ADDENDUM NO. 4 (November 23, 2020)

HOLIDAY ROAD MASTER PUMP STATION SPLITTER BOX REPLACEMENT

JEA

MITTAUER & ASSOCIATES, INC. PROJECT NO. 0801-40-2

DRAWING E-6 - BOTTOM ELECTRICAL PLAN:

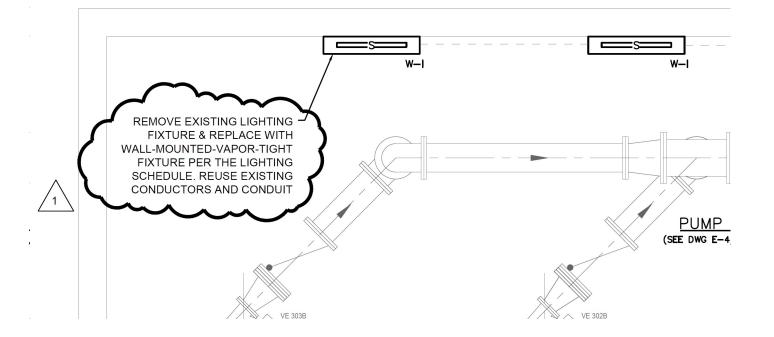
Modify the following call out:
